AERONAUTICAL TELECOMMUNICATIONS NETWORK PANEL

Working Group 3 (Applications and Upper Layers)

**SME 2 (Air-Ground ATN Applications)
Status Report**

**SV2 related PDRs
issued in the reporting period May to June 98**

- 1/ Add a new figure 2.4.5-18 as follows:

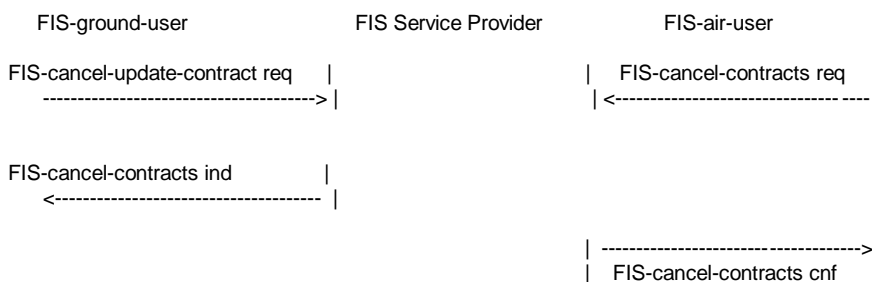
A figure describing a collision case is missing:

Impact on safety:

This situation results in the abort of the air/ground dialogue and the automatic cancellation of all pending contracts. This situation generates a false alarm to the pilot which has to figure out what is the source of the abort and then to re-install the FIS contracts which should not have normally been cancelled. This will disturb the pilot and increase the crew workload.

- 2/ Add a test on reception of a [FISCancelUpdateContract] APDU to check whether a FIS-cancel-contracts has already been initiated. If this is the case, the APDU is discarded.
